MFN 06-274

Subject: Response to RAI Letter Number 20 Related to ESBWR Design Certification Application – Seismic Design – RAI Numbers 3.7-16, 3.7-24, 3.7-27, 3.7-30, 3.7-32, 3.7-33, 3.7-35, 3.7-37, 3.7-38, 3.7-39, 3.7-50, 3.7-54 and 3.7-57

**Response to NRC RAI Letter No. 20 Related to ESBWR Design
Certification Application**

Shimizu Engineering Report																	
Project	General Electric Company ESBWR Project		Shimizu Document No.	SER-ESB-033													
Title	Parametric Evaluation of Effects on SSI Response		Rev.	0													
			Issued Date	8/14/06													
			Revised Date														
<p>NOTE:</p> <p>This document provides additional SSI analyses performed and results obtained for the Reactor/Fuel Building Complex (RBFB) the Control Building (CB) to address the following issues identified in RAIs.</p>

7.2 Effect of Layered Sites – RAI 3.7-30

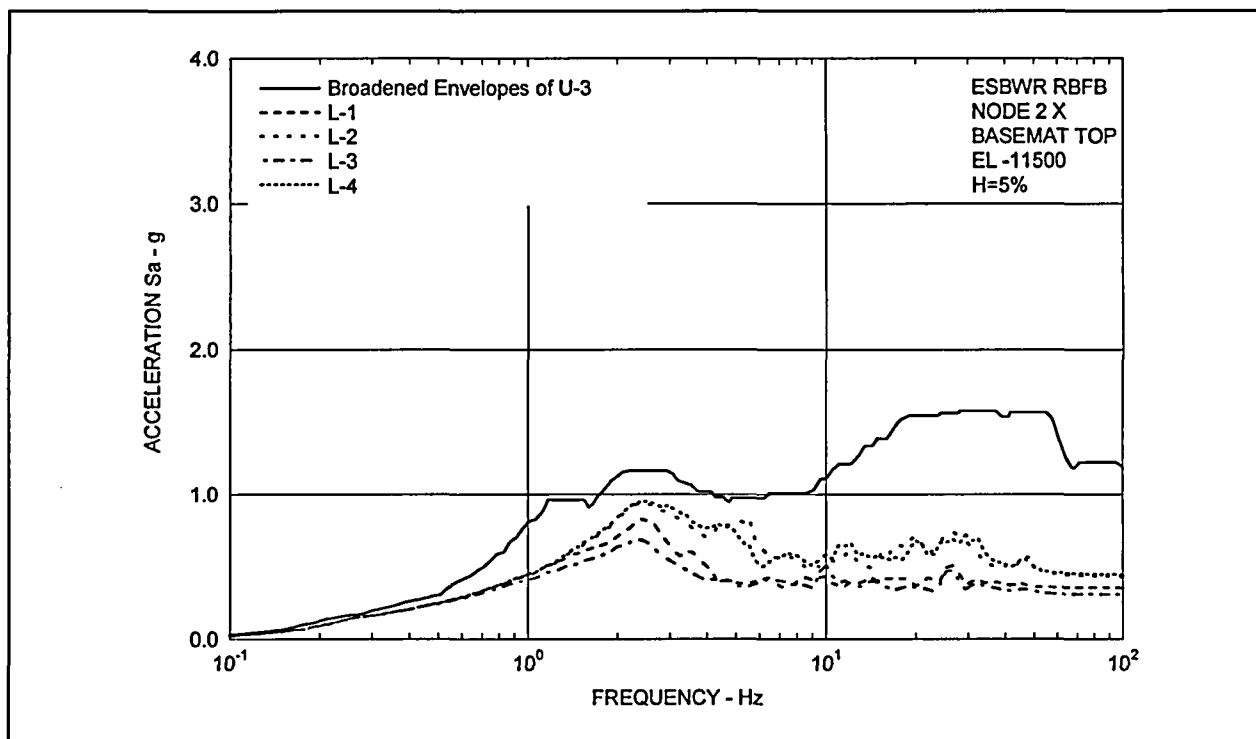
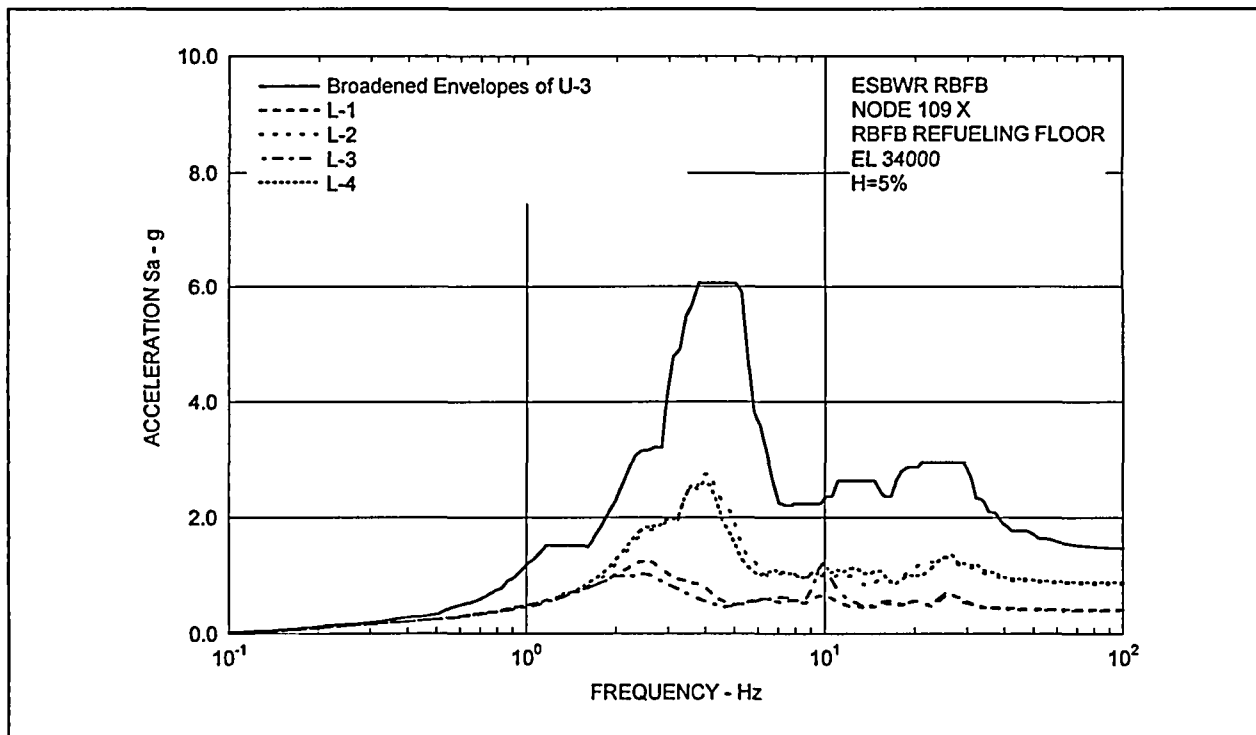
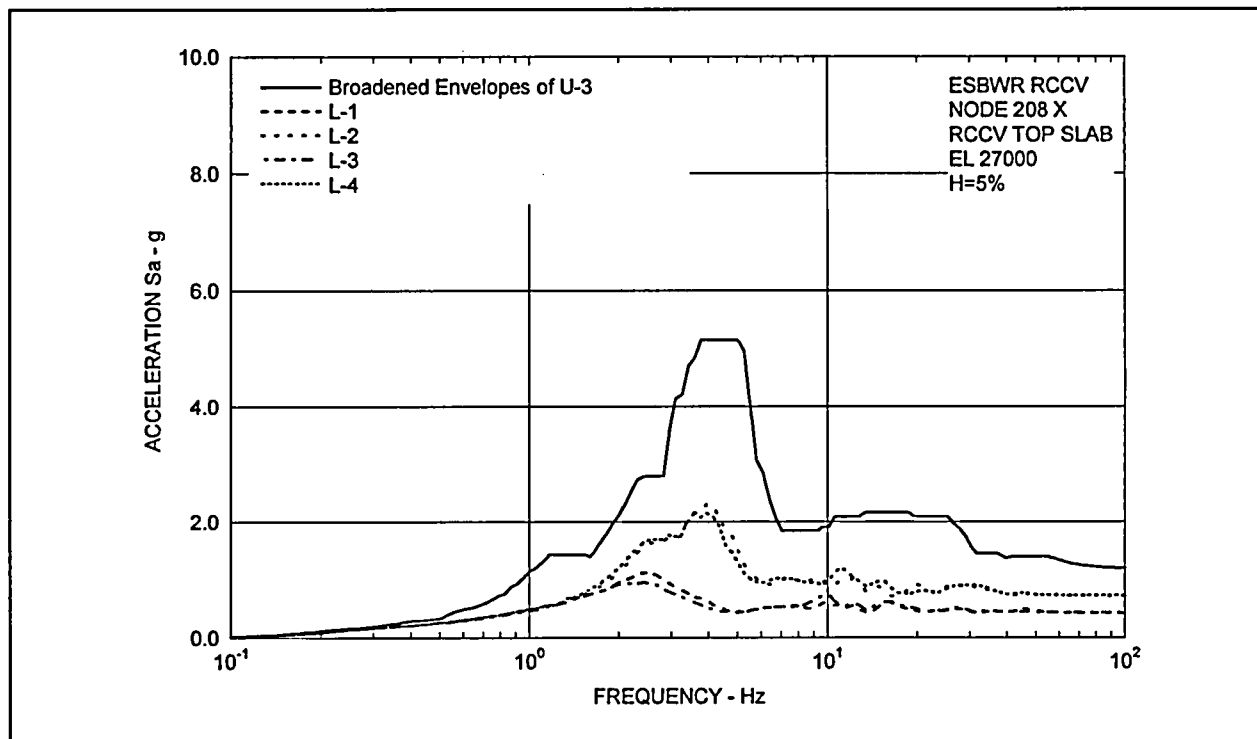
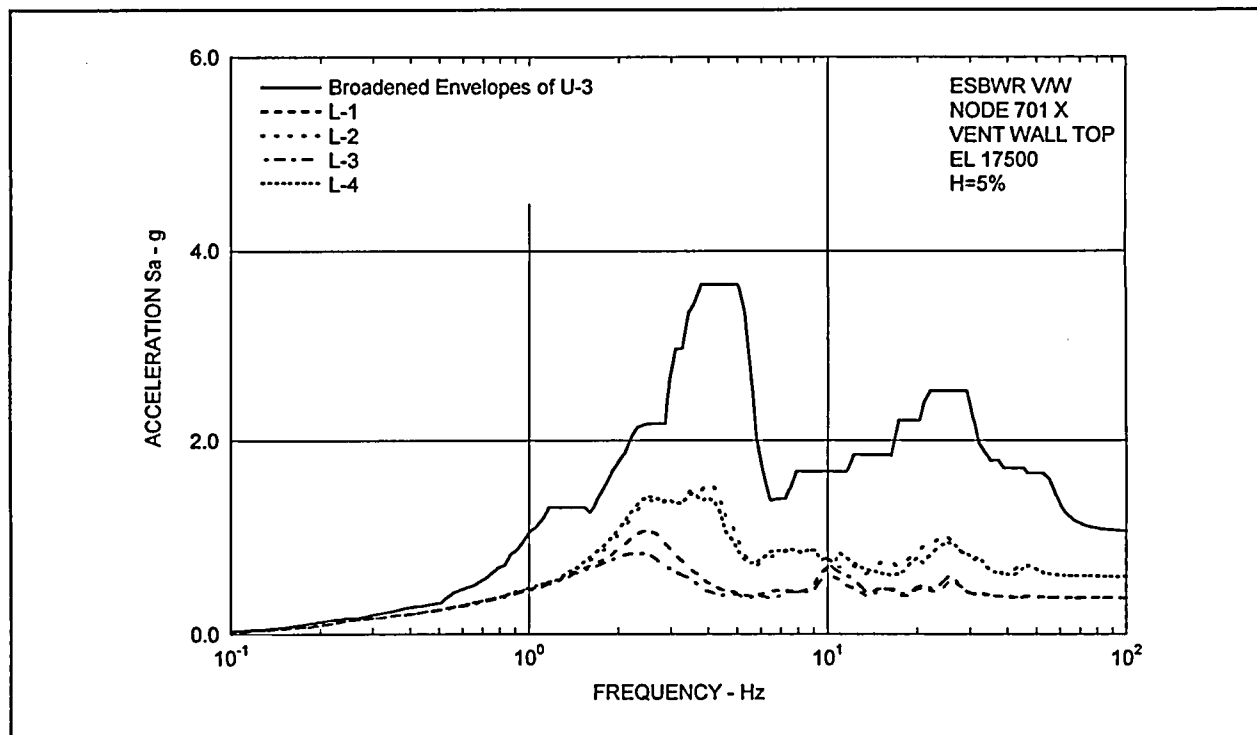
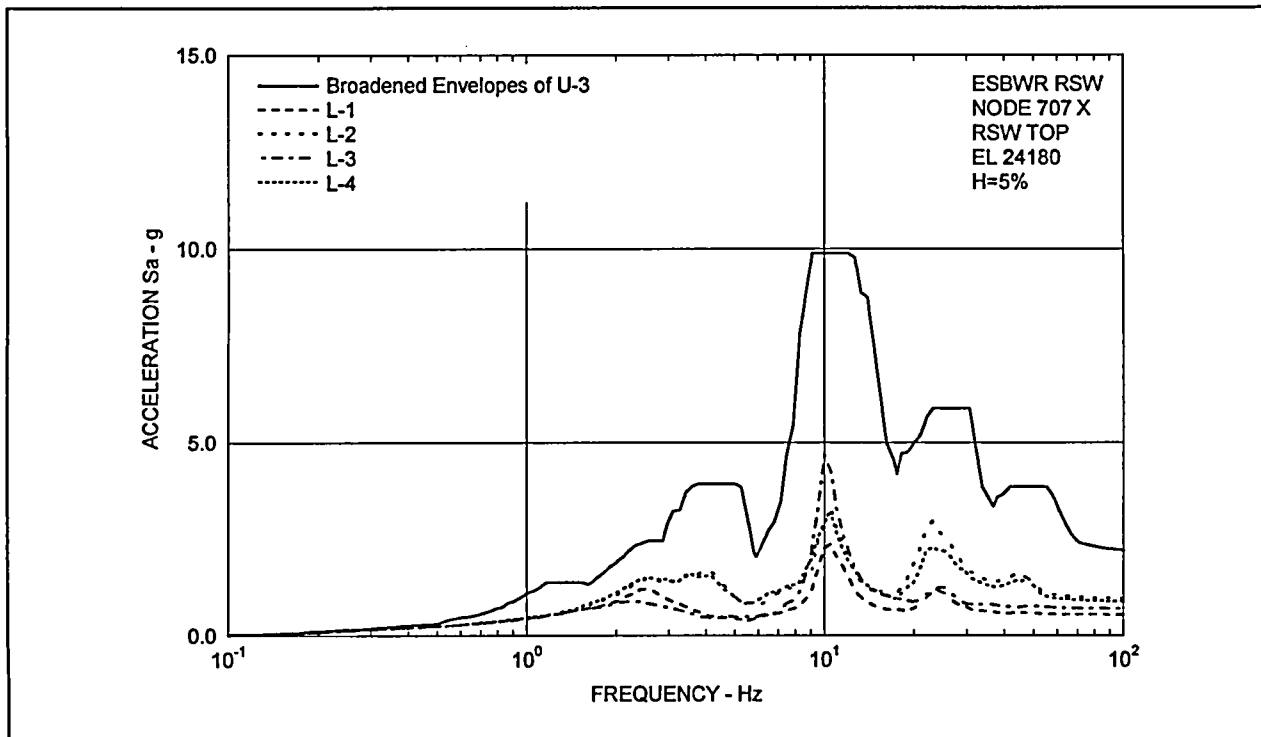
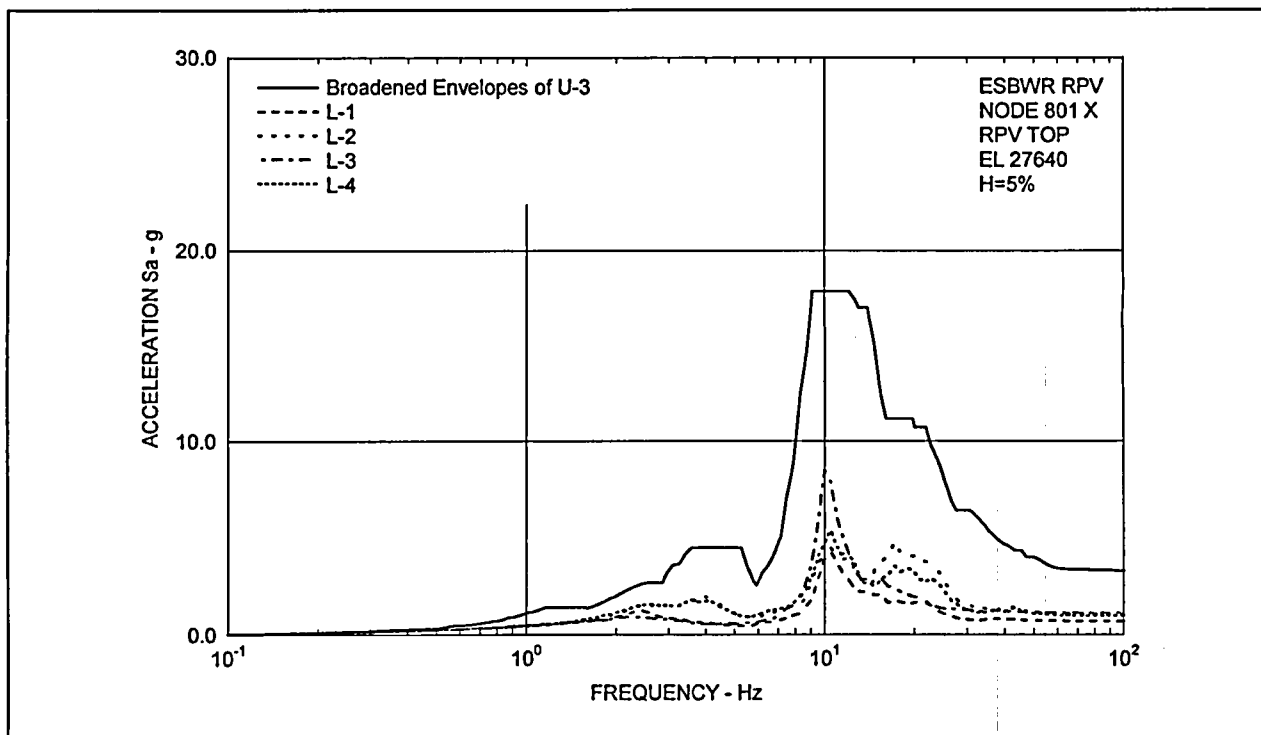
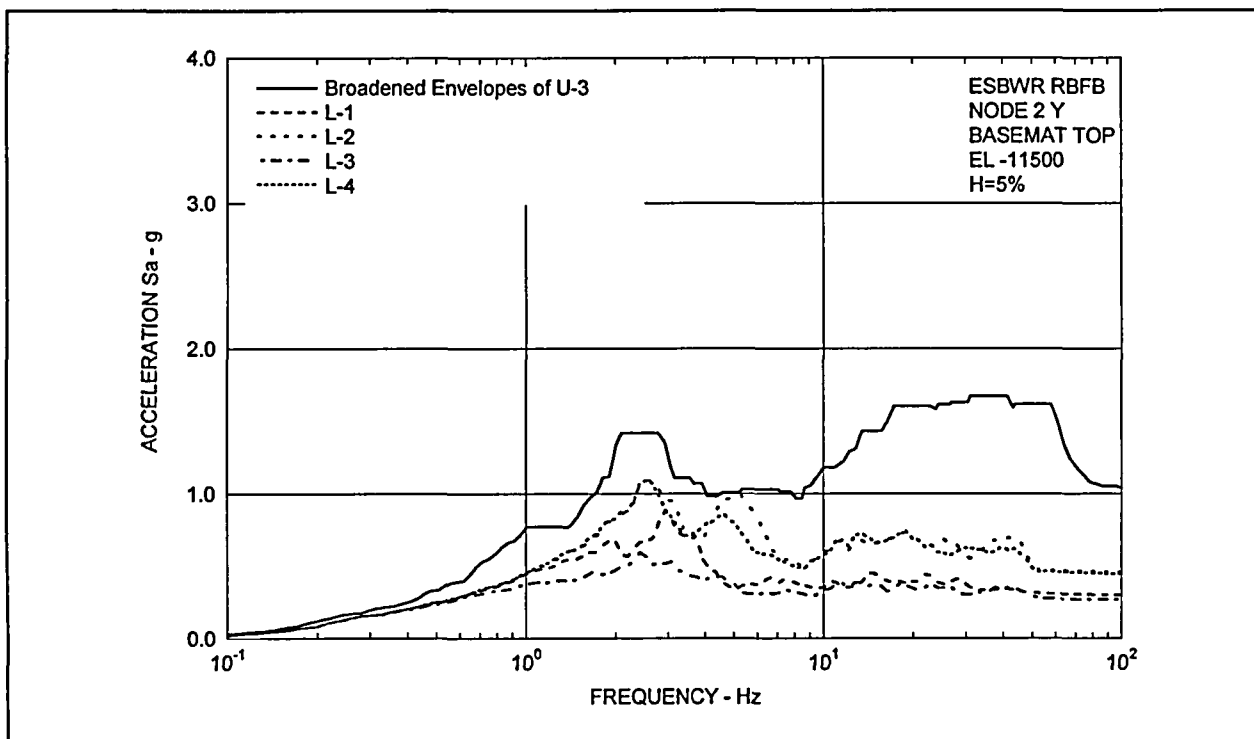
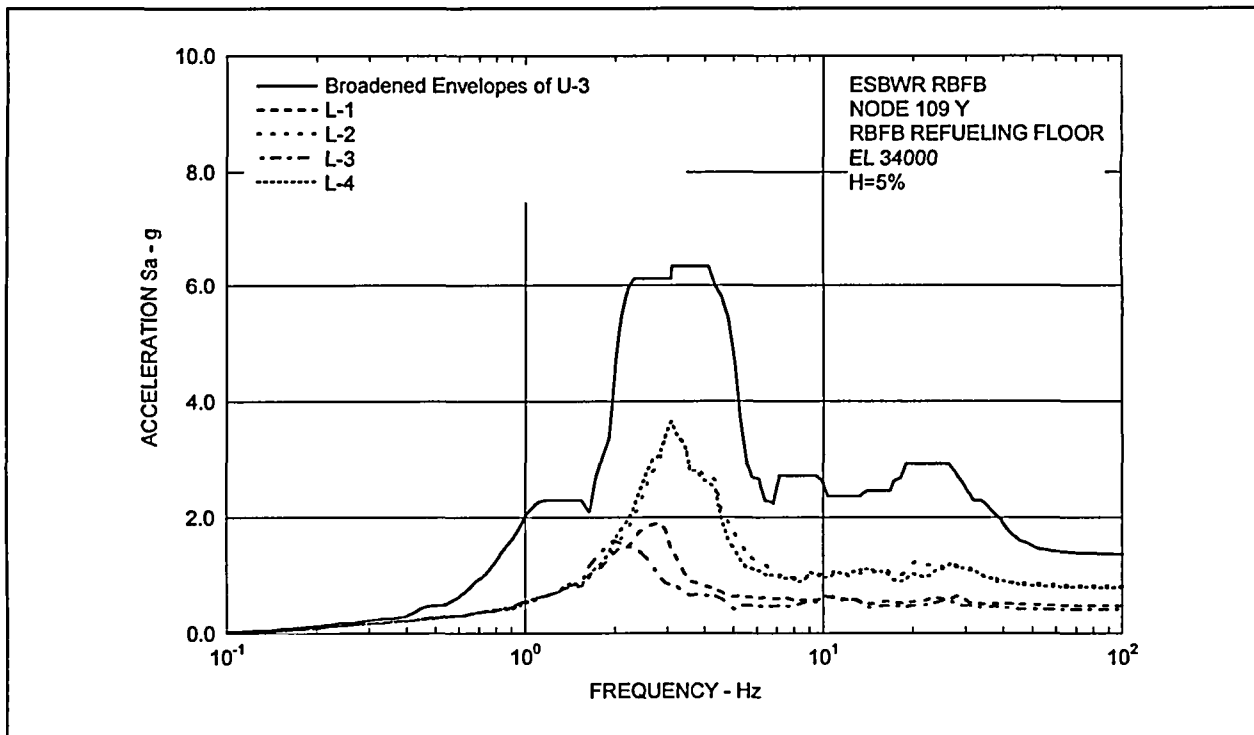
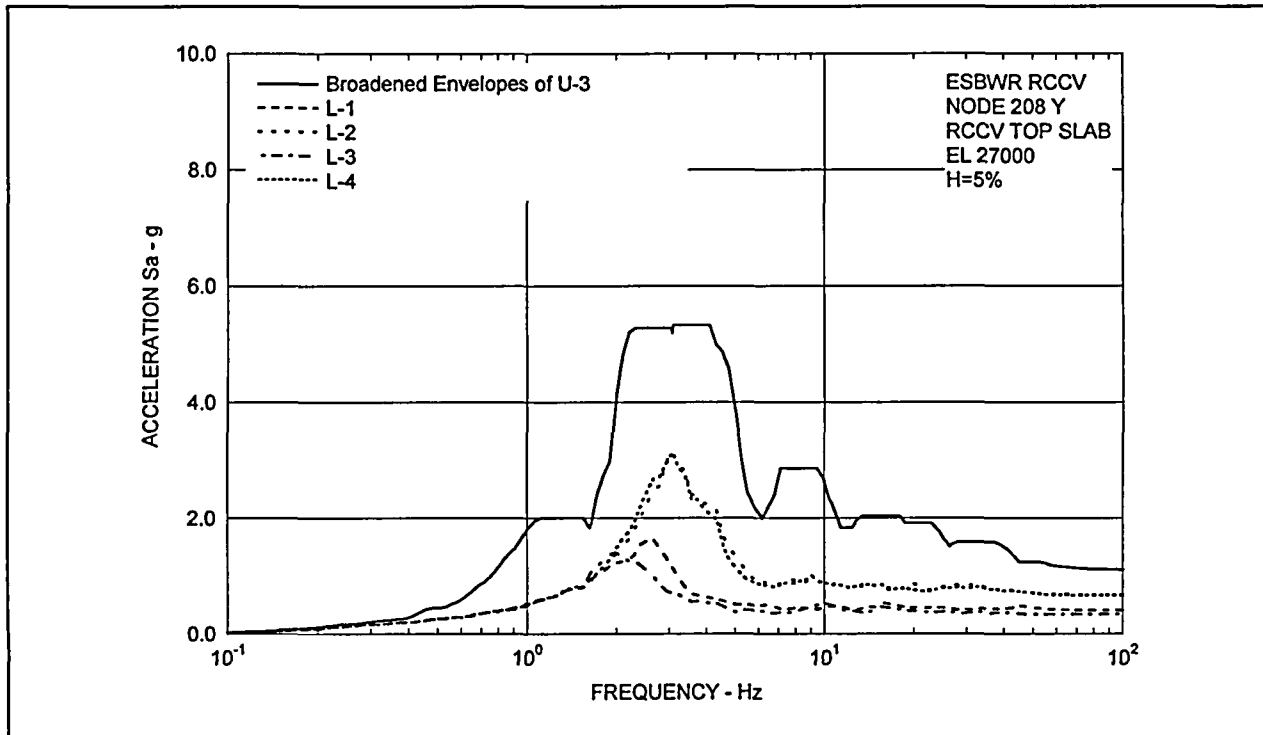
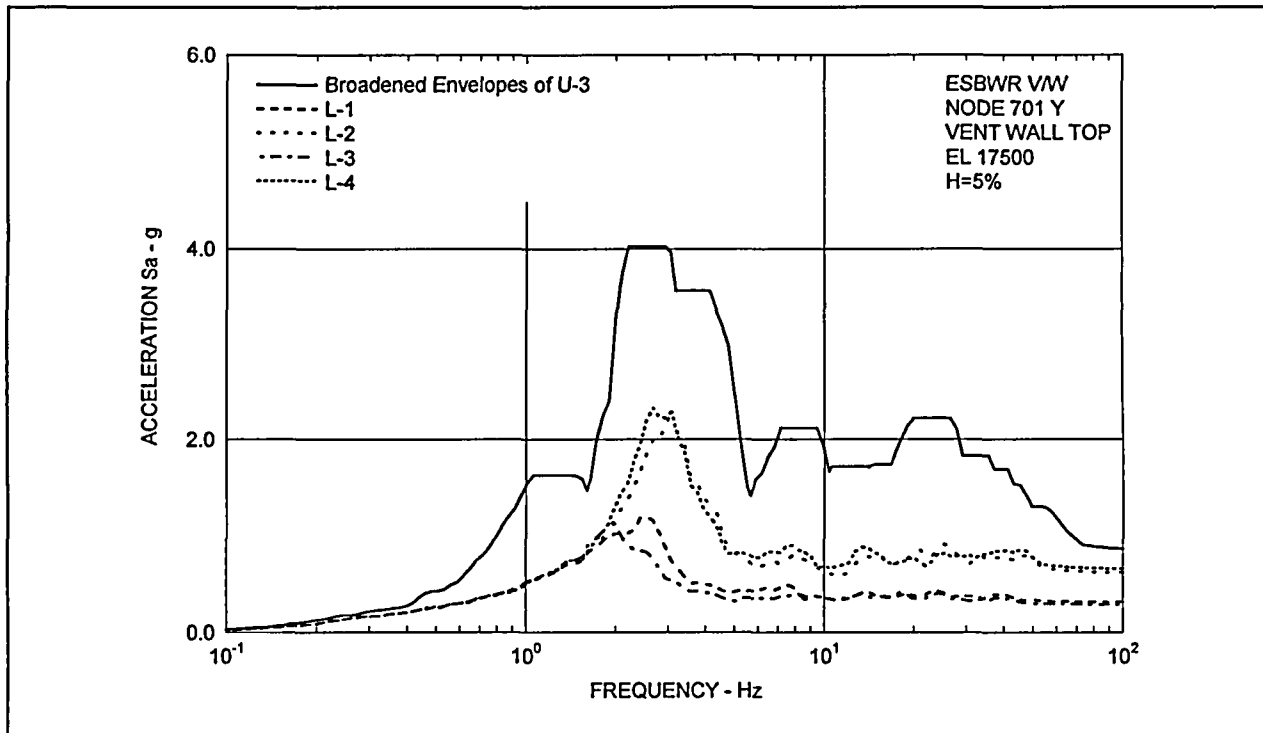
The last part of the second paragraph on page 3A-4 of DCD Section 3A.3.1 states that three subsurface conditions (soft, medium, rock and hard rock sites) are considered to be uniform half-space, as provided in Table 3A.3-1 for SSI analyses. According to the staff's review experience, there are a number of sites composed of layered materials that should be considered for siting of nuclear plants. Such sites may have significant variation of shear wave velocity with depth, leading to potentially significant impedance mismatches between layers. Such profiles can have effective impedance functions that are significantly different from those associated with a uniform half-space. (See for example, "Handbook of Impedance Functions" by Sieffert and Cevaer). These sites are typically characterized by impedance functions that are highly frequency-dependent, particularly those associated with radiation damping. The approach of using a frequency-independent assumption for both stiffness and damping in SSI may lead to significantly different computed responses. The behavior (or response) of a massive structure (such as RB/FB or CB) may be significantly influenced by these variations due to site conditions. For the design of a standard plant such as ESBWR, the DCD should address the limitations on site layering that will be required, to ensure the applicability of the ESBWR design, which is based on the assumption of uniformity. The staff requests the applicant to include this information in the DCD, and also identify it as a COL interface item.

Comparisons of floor response spectra (FRS) (5% damping) at selected RBFB locations are shown in Figures 7.2-1 through 7.2-18. Similarly, FRS (5% damping) at selected CB locations are compared in Figures 7.2-19 through 7.2-21.

It is found from the results that the responses for the layered site cases are bounded by the broadened envelope responses of uniform site cases in the whole frequency range.

As stated in Section 7.1, the existing DCD design load will be updated to incorporate the responses due to the single envelope input motion at the uniform sites. The revised DCD design load has no impact from the response results for the layered sites.
